**Bureau of Planning and Sustainability**  
Innovation. Collaboration. Practical Solutions.

## **MEMORANDUM**

**TO:** Mayor Wheeler and City Council members  
**FROM:** Sallie Edmunds, Central City, River and Environmental Planning Manager  
**COPY:** Susan Anderson, Director; Joe Zehnder, Chief Planner  
**SUBJECT:** City Council session on CC2035 on April 11, 2018

#### **33.510.223 Bird-Safe Exterior Glazing**

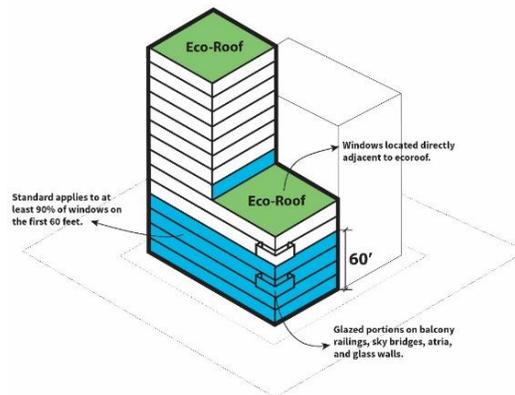
**Explanation for the amendment:** Technical and minor edits to clarify the standards for bird-safe exterior glazing. Clarification is provided that the standard applies to glazing within the first 15 feet of the building above and adjacent to an ecoroof. A diagram will be added to the commentary to show the area adjacent to an ecoroof. Finally, the last standard is updated to include glazed fences. Glass fences, of any height, may be used to separate outdoor areas within the first 60 feet of a building or adjacent to ecoroofs – these glazed fences must be treated as well.

The intention of this standard is to require new development and major remodels (except remodels of historic buildings) to use bird safe glazing techniques on windows that pose the highest risk for bird collisions: (e.g., on the lower stories of the building, near street trees and adjacent to vegetated or landscaped roof top areas or (aka ecoroofs). While the standard requires bird safe glazing within the first 15 feet adjacent to an ecoroof, the intent is to apply the standard to the first floor adjacent and above the ecoroof as shown in the diagram.

2. Windows and glazing located within the first 15 feet of the building above an adjacent ecoroof, roof garden, or other vegetated or landscaped roof area; and
